STAFF RECOMMENDATION

NCPC File No. 6597

VIETNAM VETERANS MEMORIAL VISITOR CENTER

May 28, 2009

Revised June 2009 Submission: View from the crosswalk near 22nd Street and Constitution Avenue.
In the revised 2009 submission, the applicant has added a grass berm in between the staircase and the south façade wall.

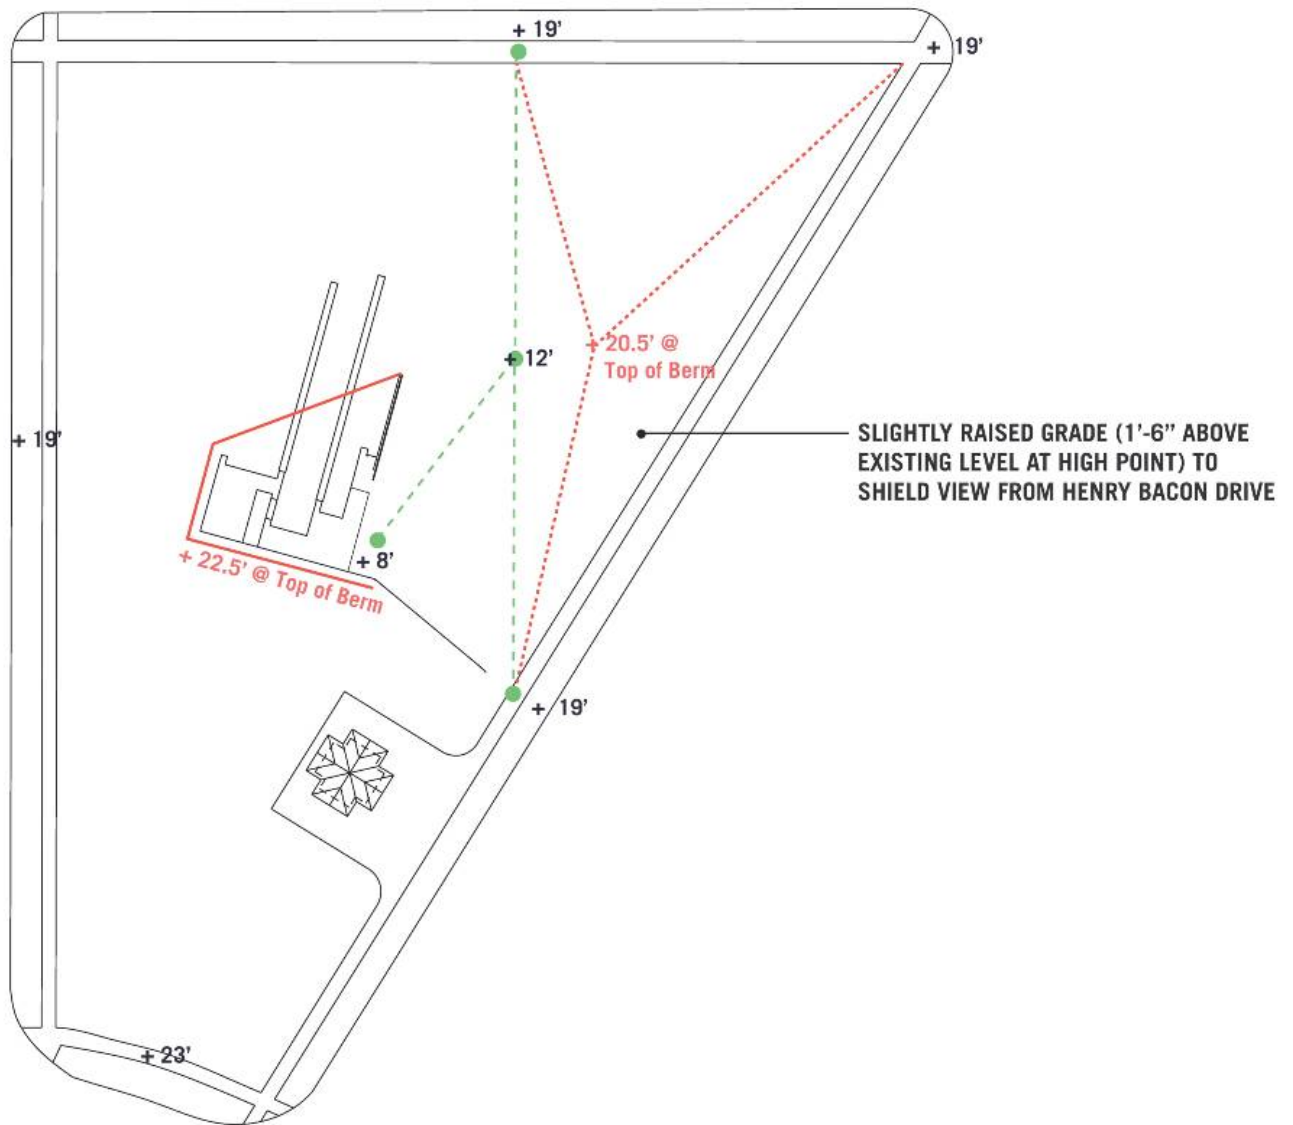
1. The applicant indicates that a landscaped and bermed zone was added between the site stair and the adjacent retaining wall, both to alleviate concerns that the experience "mimics" the Memorial, and to make the wall less visible.

Revised June 2009 Submission: View from Henry Bacon Drive.

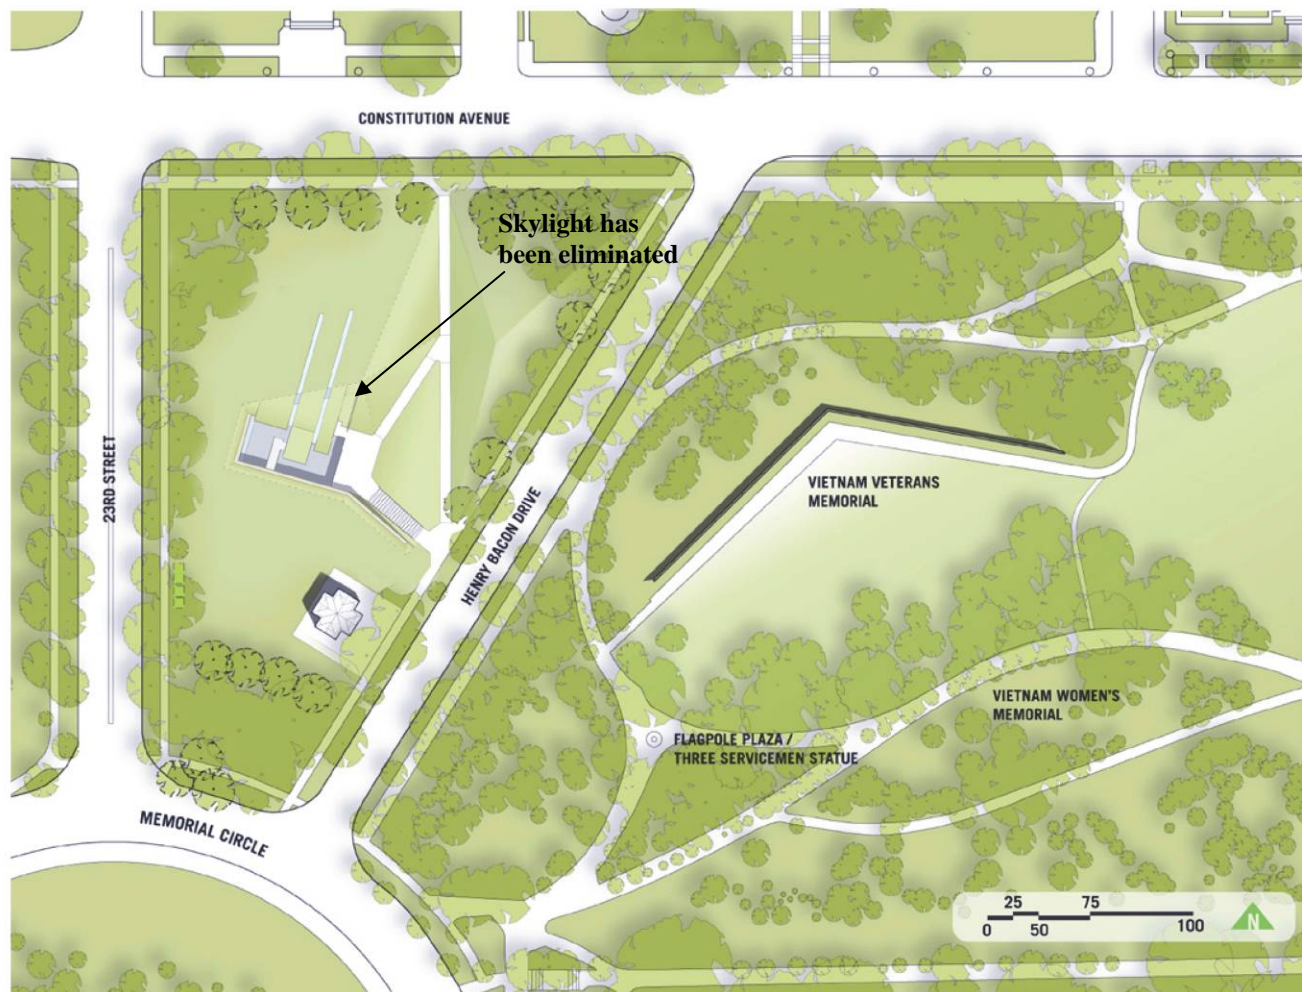
2. A slight raise in grade was added to the zone between Henry Bacon Drive and the entry ramp, such that the highest point of this raised grade is about 1'-6" higher than the existing elevation. NPS indicates that the additional raise in grade will make the Center less visible from the view along Henry Bacon Drive.

In the revised June 2009 submission, the applicant has added a subtle grass berm in the northeast corner of the site in an effort to make the south and east façade walls of the Center less visible.

Revised June 2009 submission: View from corner of 23rd Street and Constitution Ave
The pathway and exhibit skylights are less visible because of the 3.5' raise in grade

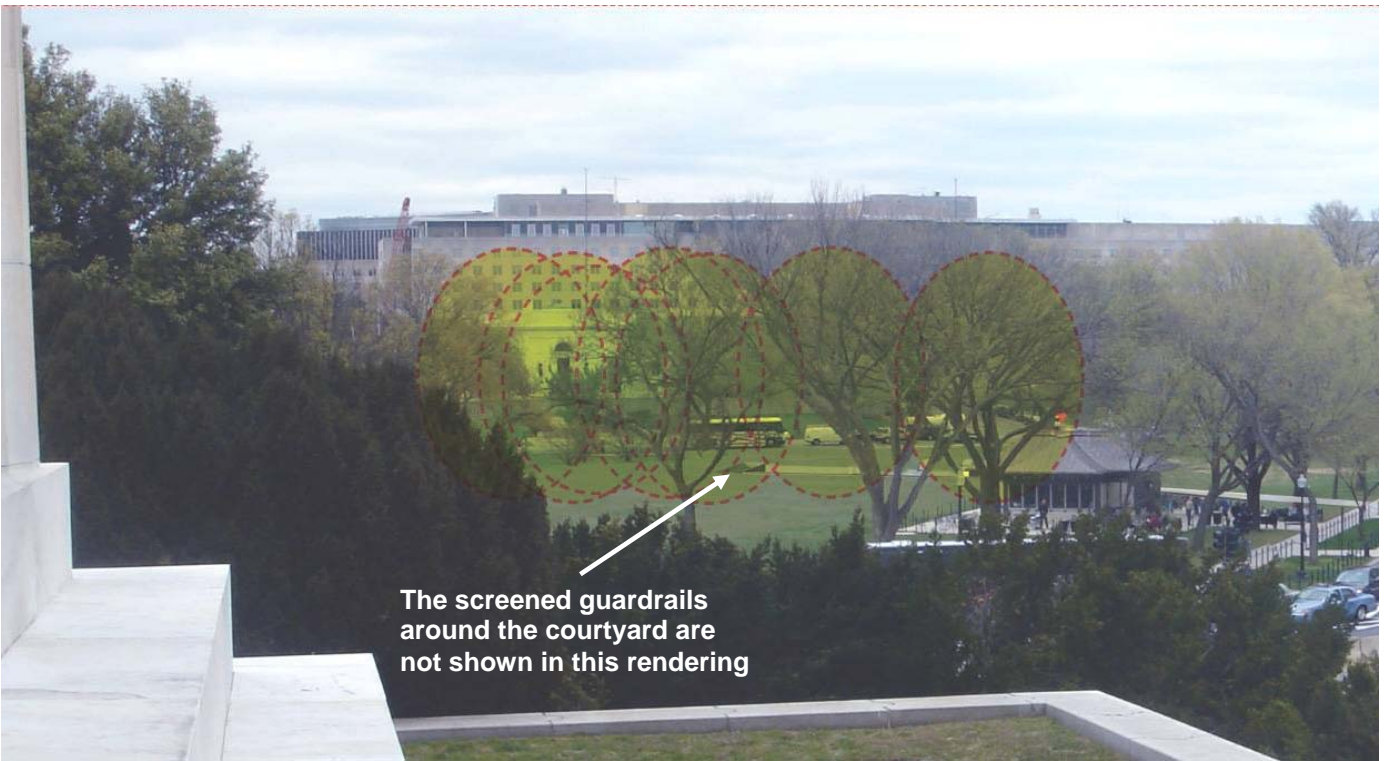
The scale of the building openings has not been reduced and as a result the building is still visible from the Lincoln Memorial, Constitution Avenue, and from within the axial view sheds of 23rd Street, NW and Henry Bacon Drive. The courtyard and newly added guardrails will be visible from the Lincoln Memorial Stairs. While raising the grade of the site has reduced the visibility of the Center from the corner of 23rd and Constitution Avenue, the south wall of the Center and the entry court are now more visible from the crosswalk at Constitution Avenue and 22nd Street; and, the south and east walls are now more visible from Henry Bacon Drive. In response to staff concerns about visibility, the applicant raised the site of the northeast corner by 1.5 feet; however, it does little to reduce the visibility of these building elements.

The ramp from Constitution Avenue and the resulting cut in the bermed area of the site make the south wall and the entryway of the Center more visible from Constitution Avenue. The ramp descends 11' to the entryway which creates a cut in the site that breaks up the landscape and limits the potential for recreational use. Staff contends that the most critical relationship of the proposed Center is to the Vietnam Veteran's Memorial across Henry Bacon Drive, not to Constitution Avenue. The majority of people will come to the Center from the Memorial at the mid-block crossing and by tour buses that will unload in the parking lane along Henry Bacon Drive (near the Center's entry stairs and ADA ramp). Pedestrians wishing to reach the Memorial from Constitution Avenue would have to navigate a circuitous route descending first into Center's entry plaza, then back up to Henry Bacon Drive, and finally doubling back to the Memorial's entry point. While the existing desire line at the northeast corner of the site shows that some visitors are arriving from the north, the proposed ramped walkway will not replace the

The Center is less visible from this viewpoint

Revised June 2009 submission: View from corner of 23rd Street and Constitution Ave
The exhibit skylights are less visible because the grade of the site has been raised and the skylights are now flush with the grass. The south wall of the building and the walkway and adjacent slopes are now more visible.

desire line path. Therefore it is staff's opinion that given the ramp's impact on the site and on views from Constitution Avenue, and given its limited utility, that it should be eliminated.

Revised June 2009 Concept: View from Henry Bacon Drive Looking South
The east and south façade are now more visible from Henry Bacon Drive.

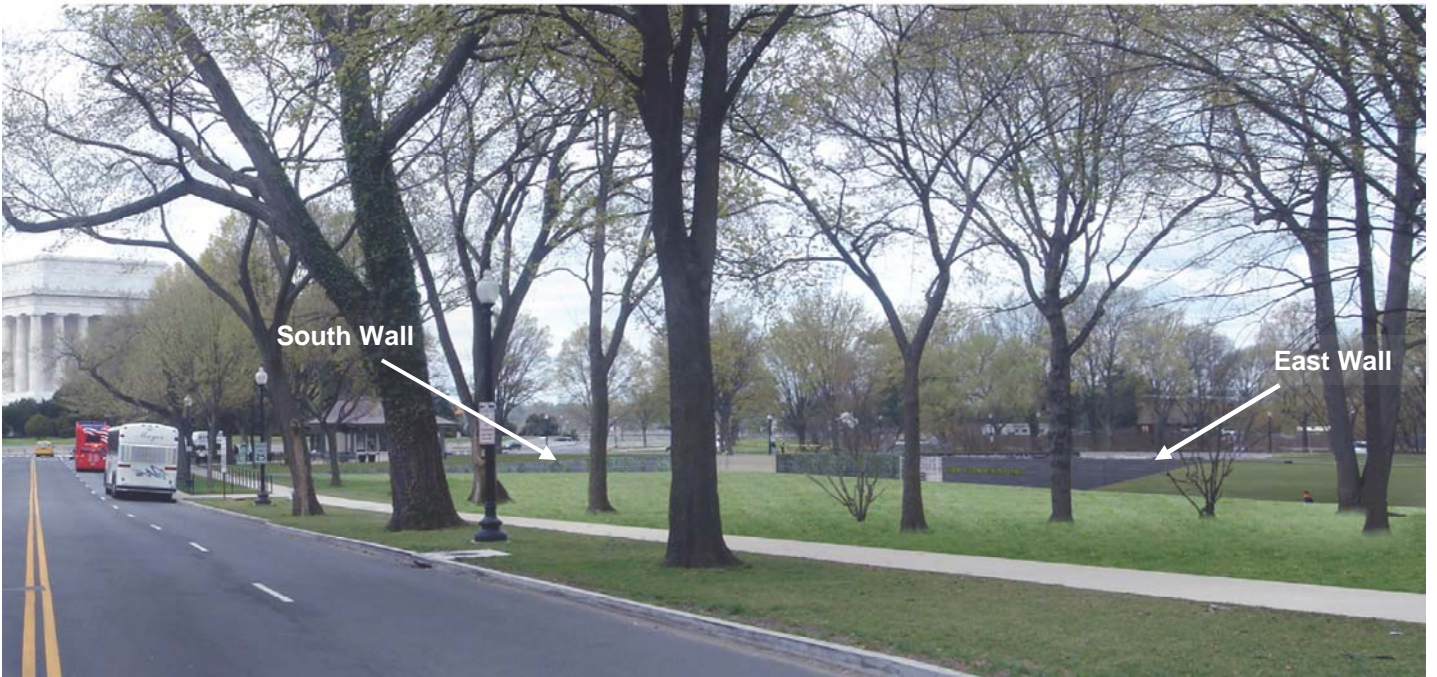
June 2009 submission: View from the top stair of the Lincoln Memorial Steps
The opening of the courtyard is still visible in the landscape below. The new guardrails are not shown in this rendering and would be visible. Even if the proposed Elm trees help to block the view of the Center when they are fully grown, it will only be for the time of year when they have leaves.

Existing and Proposed Crossings

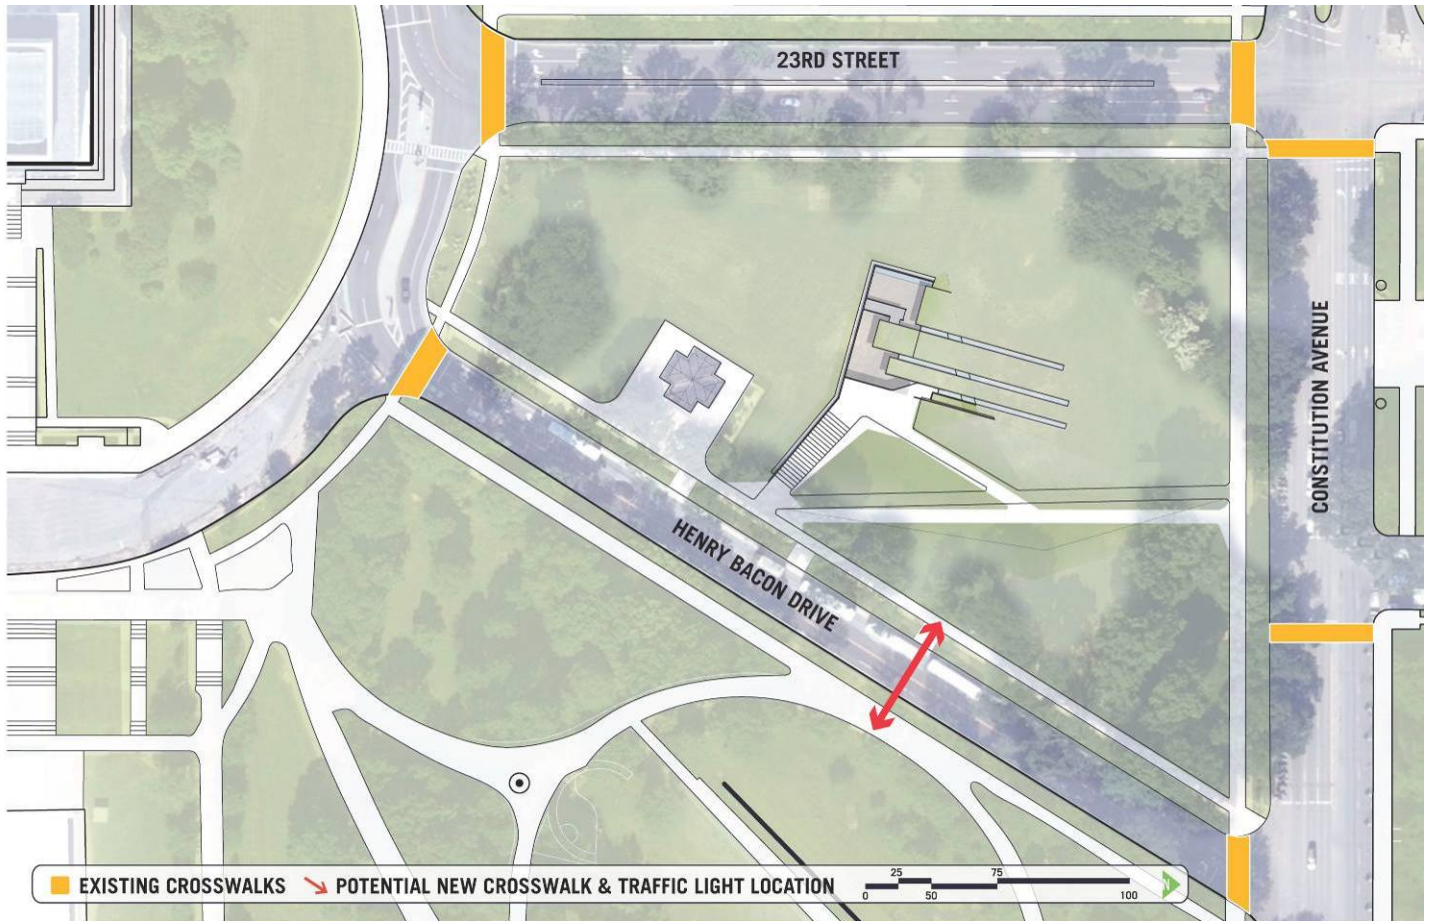
NPS has not yet designed the project's pedestrian crossing points even though designs for the Center are moving forward. Since the crossing points will have an impact on the design of the site, it is important that both move forward in coordination. The crossing points must be designed to meet the design guideline. The design team should work with the District Department of Transportation and the National Park Service to design any required crossing

*FURTHER DISCUSSION REQ'D WITH NPS & DC DOT

points including the mid-block crossing on Henry Bacon Drive to address traffic impacts effectively, to design the building orientation accordingly, and to protect pedestrian safety.

Proposed critical root zone (a technical survey is underway)

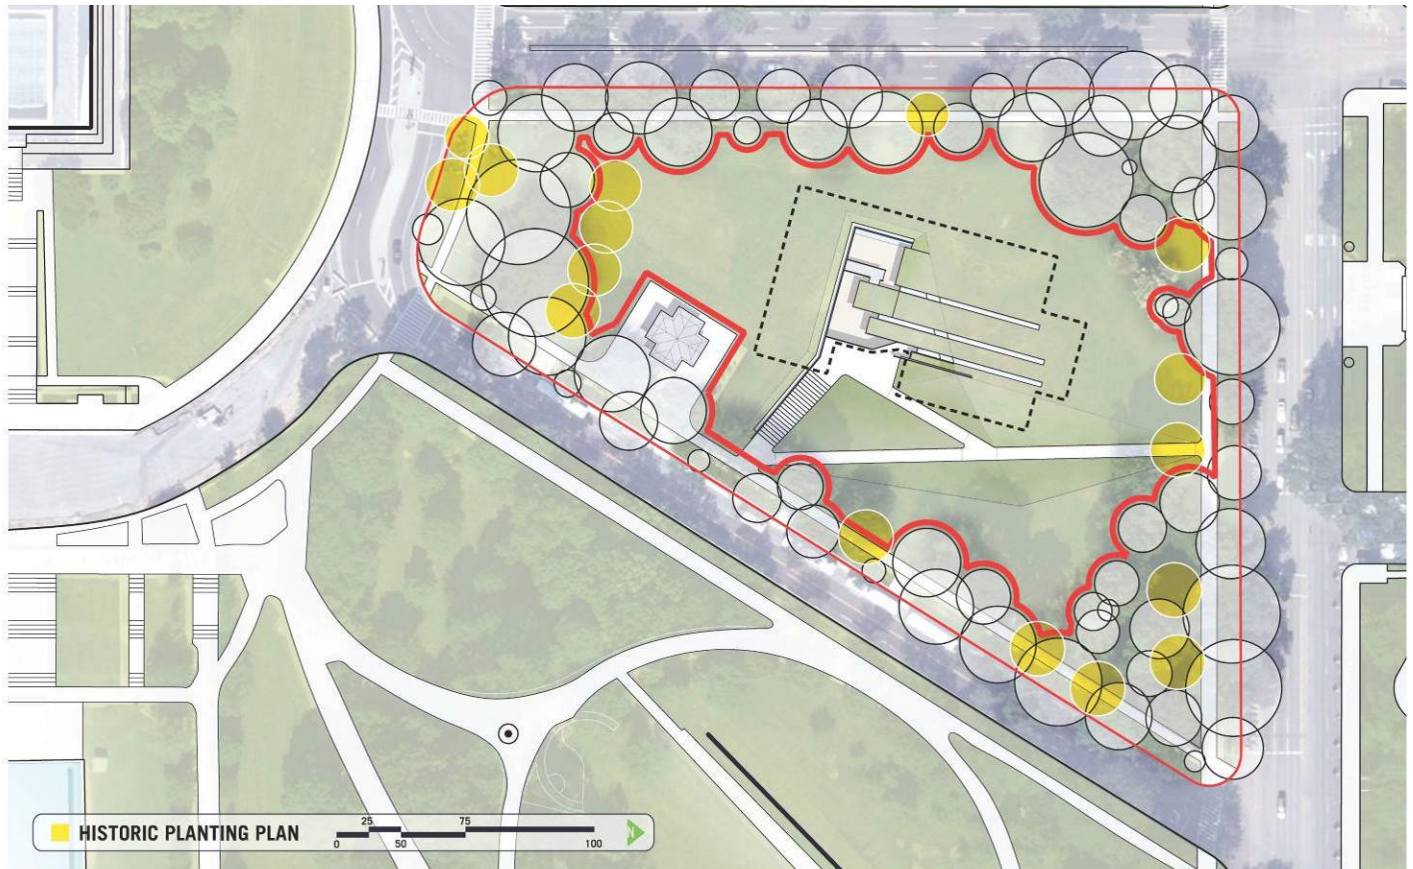
The applicant has reoriented the Center further to the north and to the east to move it away from the perimeter tree root zone. The applicant has noted that the technical survey of the critical root zone of the existing elm trees is underway.

The site is surrounded on its perimeter by mature elm trees that are part of the historic grounds of the Lincoln Memorial. Construction of a building on this site will require that heavy construction equipment pass among the trees during the construction period. It is imperative that the applicant develop a tree protection plan in accordance with standard construction procedures.

*SITE SURVEY IN PROGRESS

A semi-transparent screen (guardrail) is proposed for the north side of the courtyard

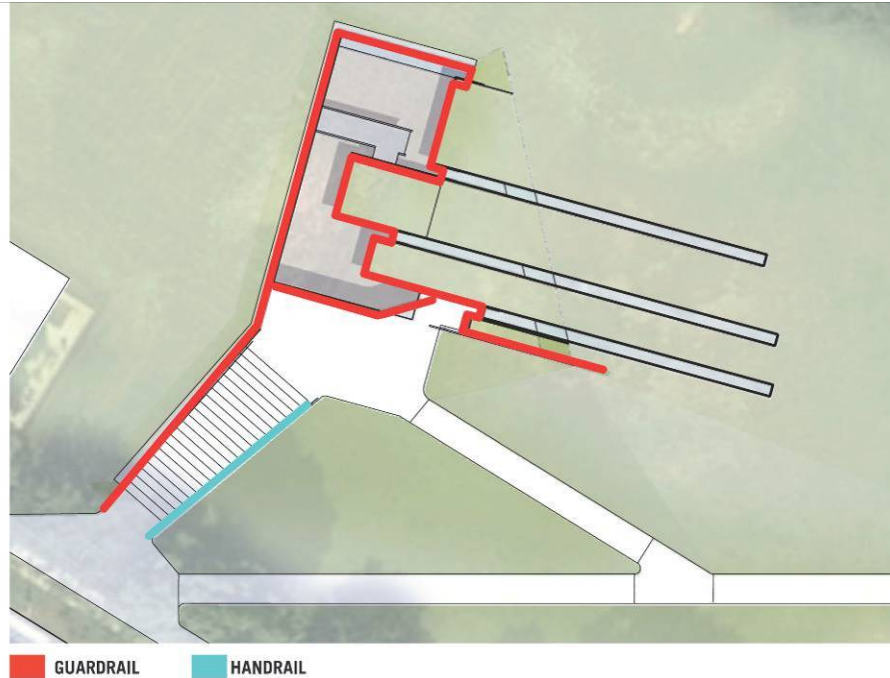
The complex design of the two-story courtyard will necessitate a circuitous system of guardrails. In addition to the guard rails at the bottom of the ha-ha walls along the south and west side of the courtyard, the revised concept shows that a screen wall on the north side of the courtyard will extend upward to function as a guardrail. There will also be a guardrail in the entryway area that overlooks the courtyard and around the roof of the emergency access stairwell. Staff is concerned that system of guardrails along the north side of the courtyard will be visible from the Lincoln Memorial since the courtyard itself is visible from this viewpoint.

The hatched area shows the amount of area that would be made available with the recommendations.

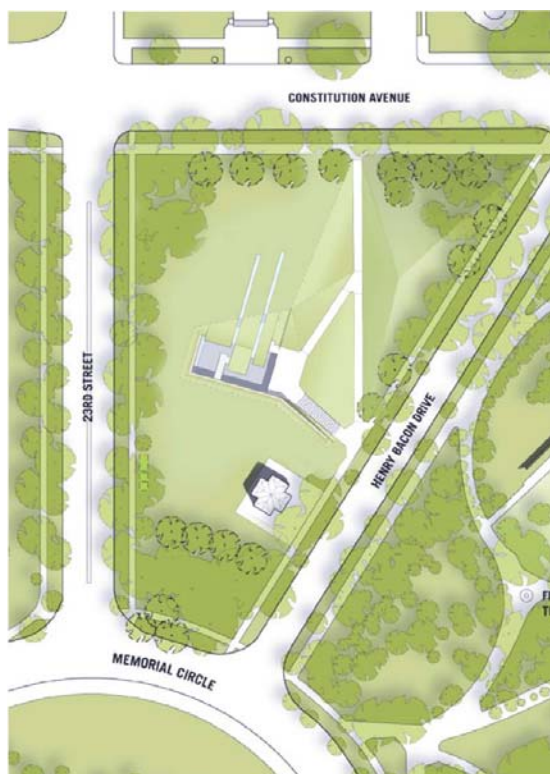
- **Eliminate the walk from Constitution Avenue and associated berms so that the Center is less visible from Constitution Avenue and Henry Bacon Drive. This will also allow for more multi-recreational use on the site.**
- **Eliminate the skylights to minimize the Center's intrusion on the landscape and to allow for multi-recreational use on the site.**
- **Reduce the size of the open courtyard and the length of needed guardrails to minimize visibility from the Lincoln Memorial.**

June 2009 Submission: Rendering of the ramp and the Center from Constitution Avenue

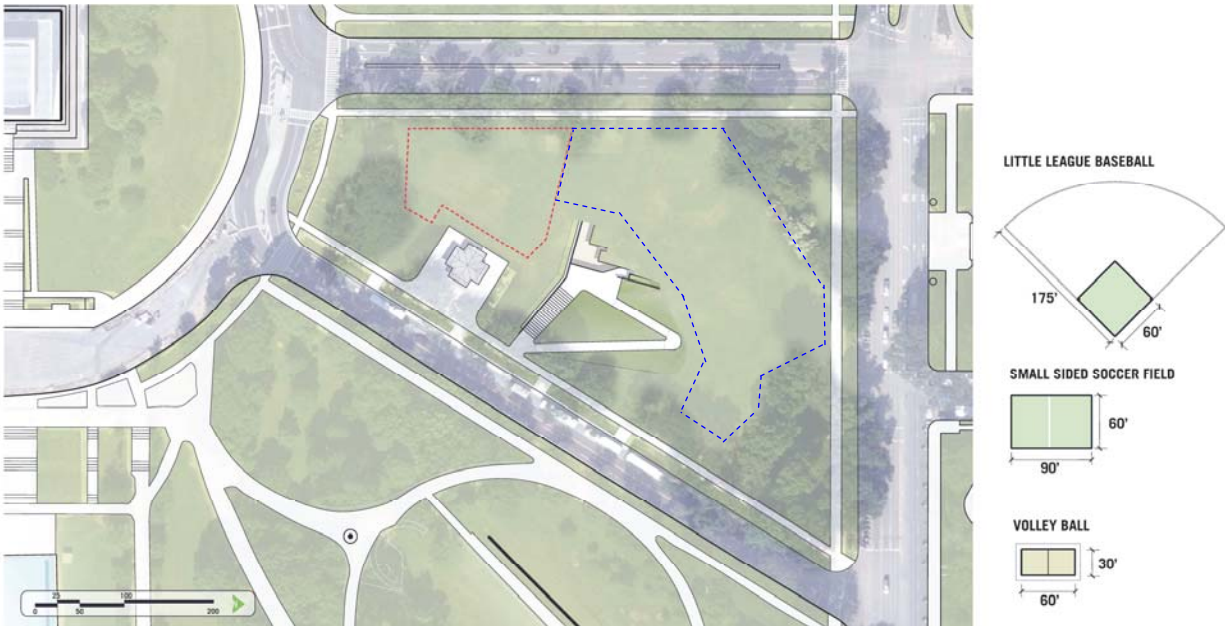
Revised June 2009 Concept: View from corner of 23rd Street and Constitution Ave
While raising the grade has helped to minimize the visibility of the skylights from Constitution Avenue, the south facade wall and cut in the site needed for the walkway from Constitution Avenue are now more visible.

Eliminating the walkway and associated berms that are needed for the walkway to descend 11' to the entryway of the Center would minimize visibility of the Center from Constitution Avenue and maintain a large open area for multi-purpose recreation.
